# Rufus 2.0 - Block 19

## Purpose of Recommendation Meeting #3

FIGURE 5A

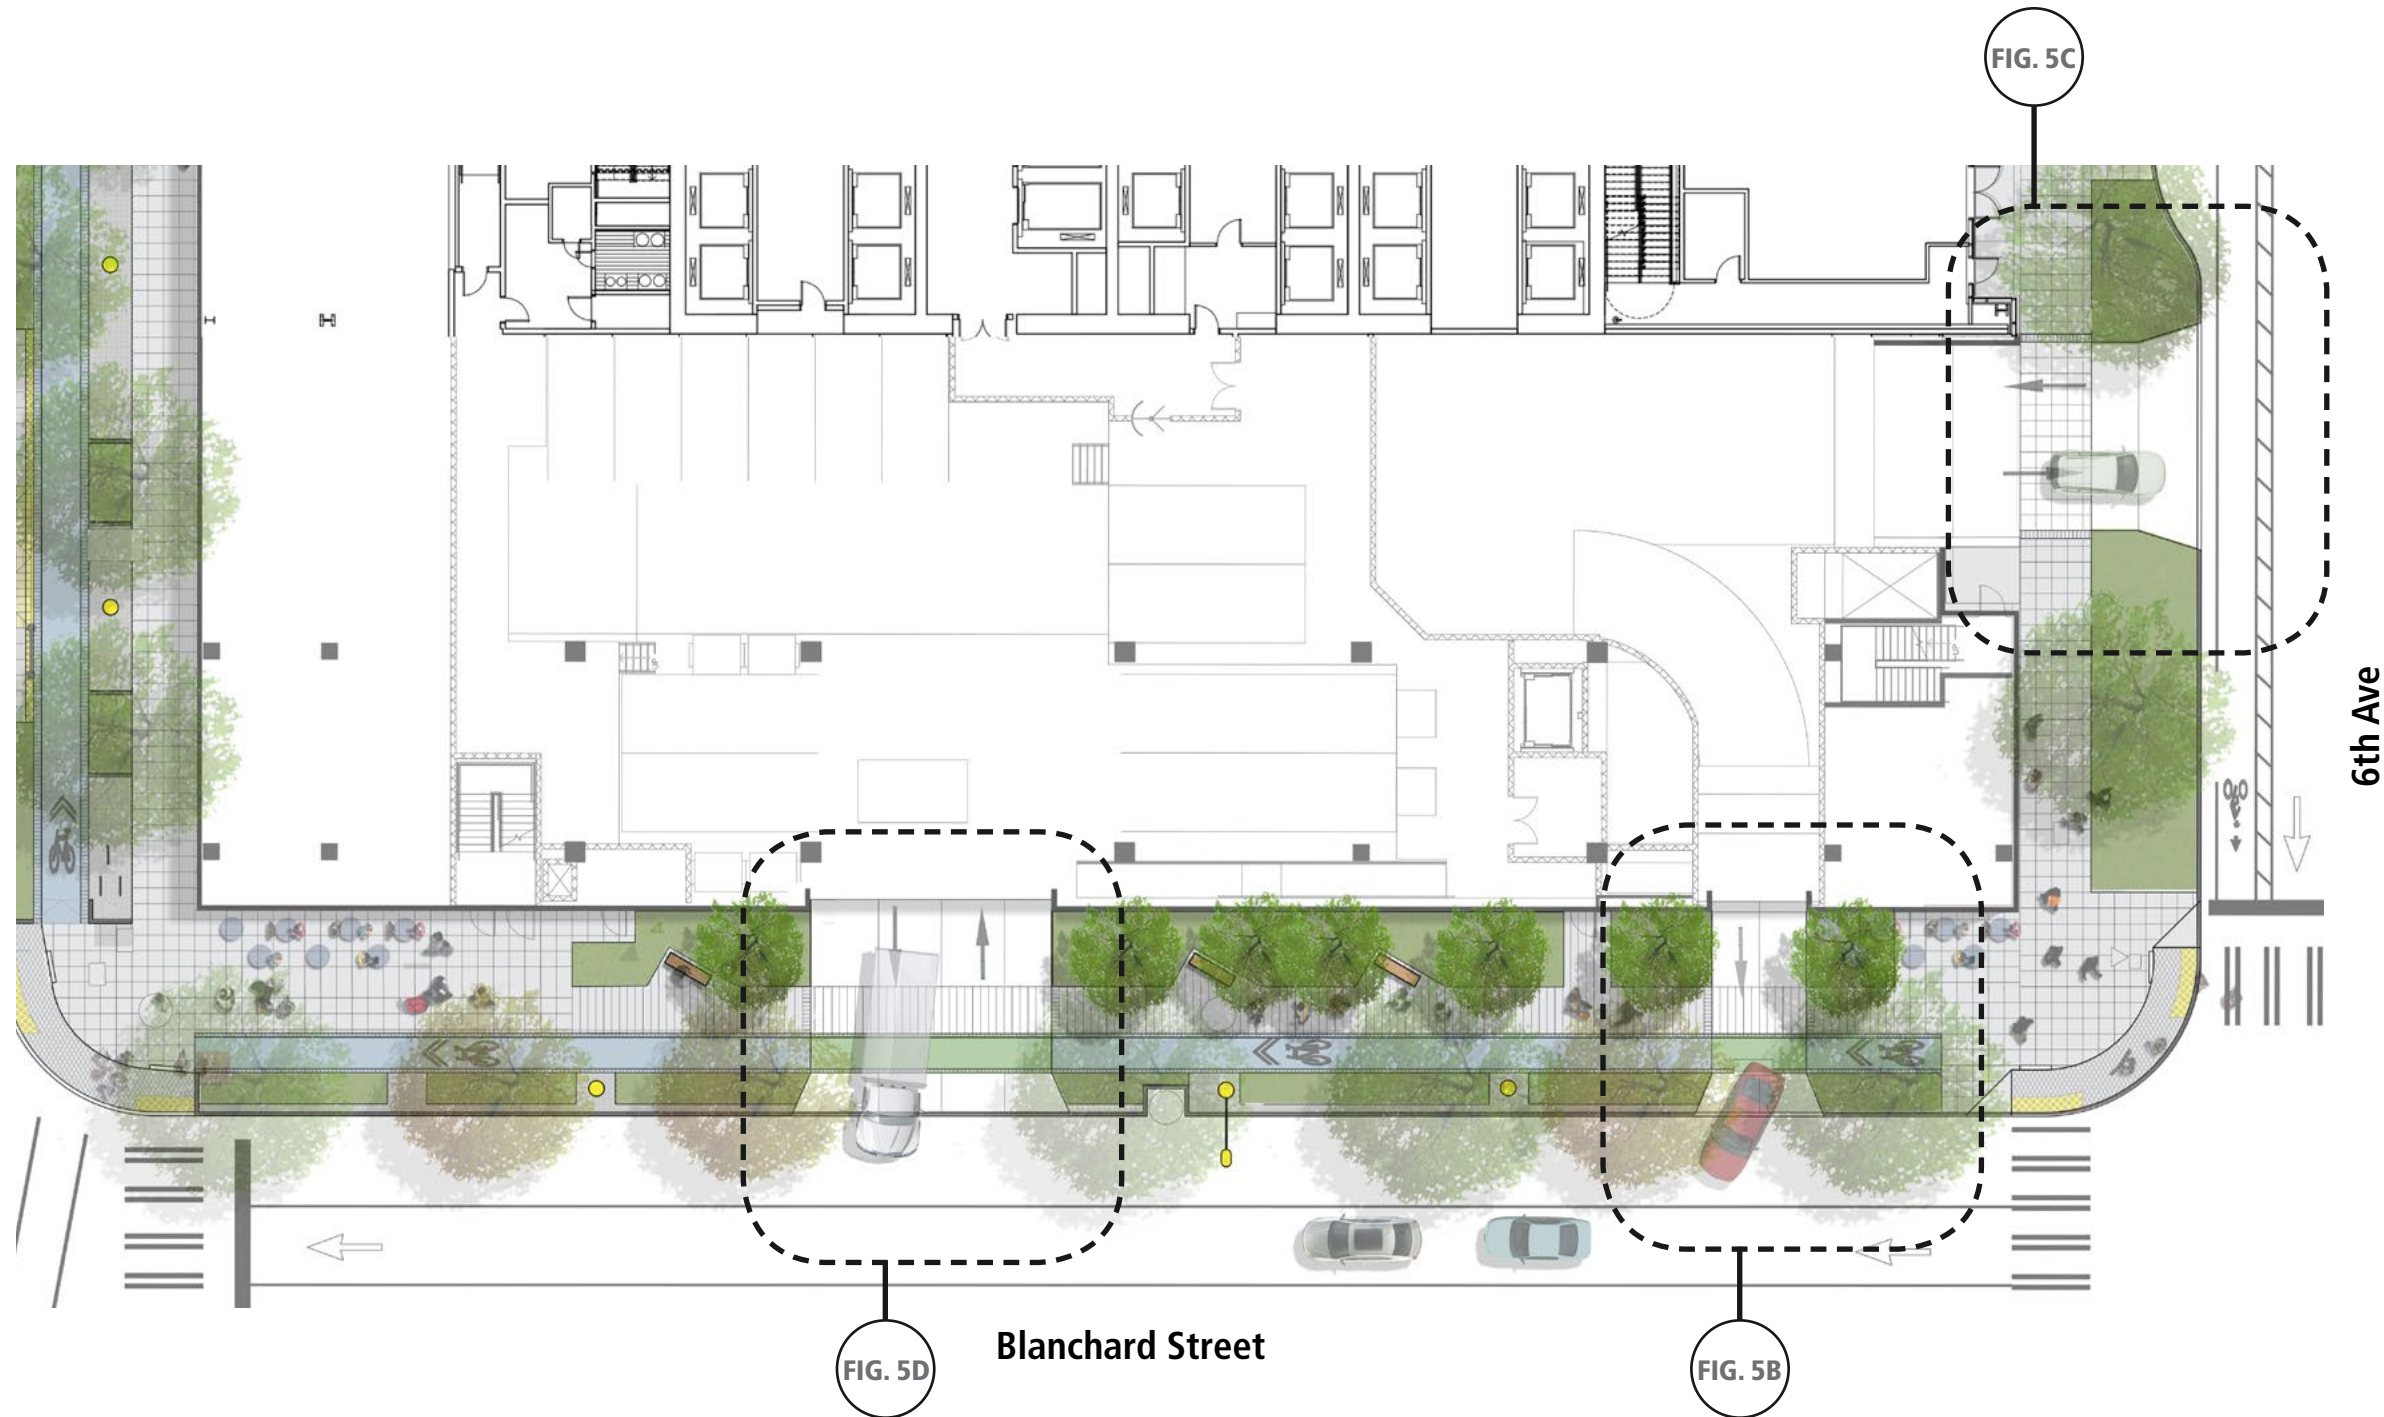
a. The Board was very supportive of moving the driveway away from Lenora to another location. The Board understanding that this is part of an on-going discussion with SDOT. (E-1, E-3)

b. The Board will continue to be interested in how pedestrian safety and ground level engagement and visual interest will be addressed in the revised driveway location. (E-1, E-3, D-6)

Lenora remains free of curbcuts. The proposed relocation of the driveway now occurs on Blanchard Street near 6th Avenue. This new location is an exit only, one lane driveway. See Figures 5A and 5B which show the proposed curbcut.

The Blanchard landscape plan has been redeveloped and is shown in Figure 5A. Additionally, each curbcut on the block is shown in an enlarged plan and elevation in Figures 5B,C and D. An experiential view walking along Blanchard is shown in Figure 5E along with a more wholistic night view of Blanchard seen in Figure 5F.

FIGURE 6D

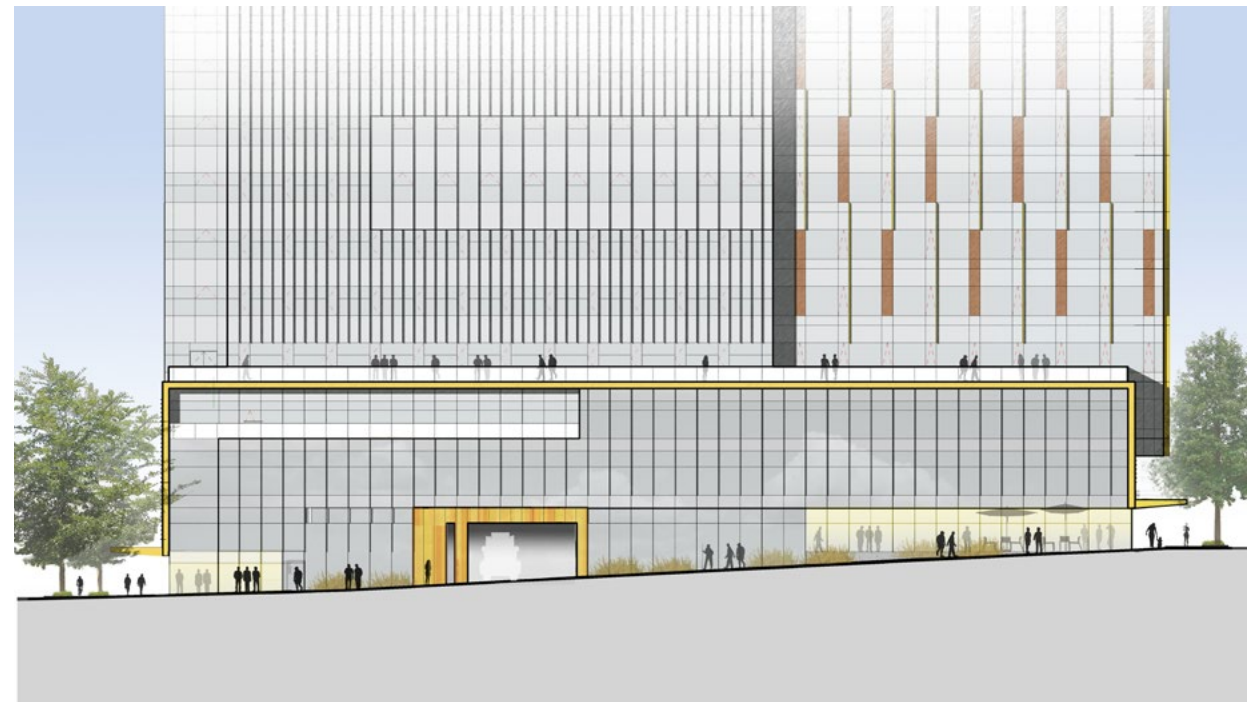
b. The Board would like to see additional detail at the next meeting, including elevations of the previously approved design.

The previously approved building elevations are shown in Figure 6D. Proposed building elevations are shown in Figures 6E, F, G & H.

Departure #4 Diagram

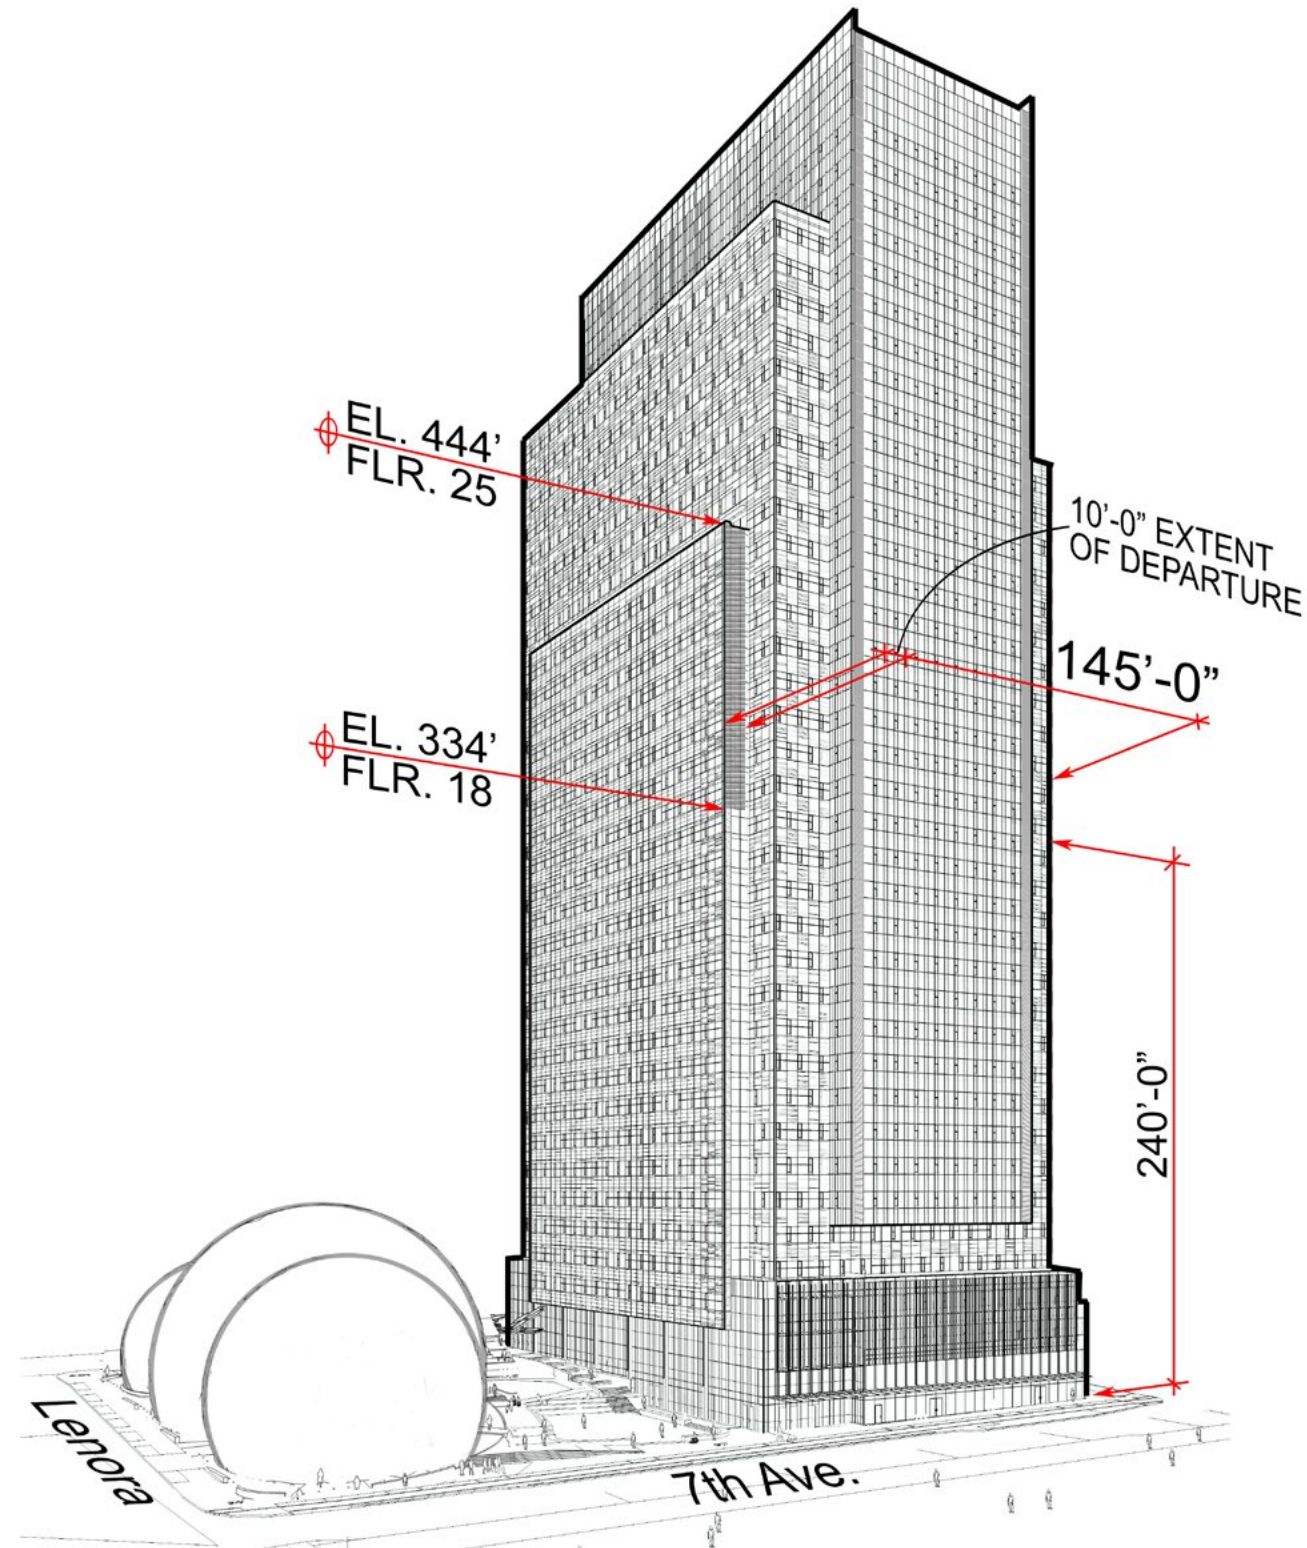
This is a new departure proposed as part of the re-design effort. The Board was inclined towards such a departure as it results in better tower massing and proportions. (B-4)

Departure request unchanged.
